Operations Panel Fact-Finding Status

Col. James Adamson, Lead

RTF TG

Operations Panel CAIB Recommendations

35mm Umbilical Well Camera Imagery

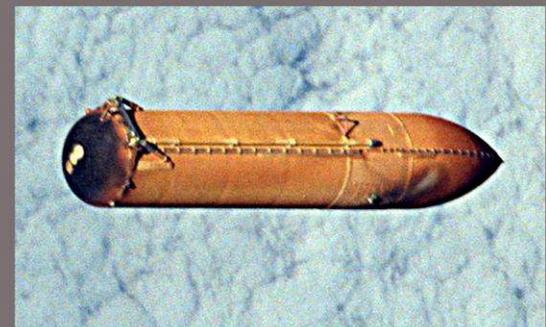
Panel Assessment

- Conducted fact-finding at KSC
- Appropriate cameras have been selected
- NASA has accelerated the installation of the digital umbilical well camera to meet STS-114 milestones
- NASA has completed or scheduled all of the remaining work that will allow this additional capability to be flown on STS-114
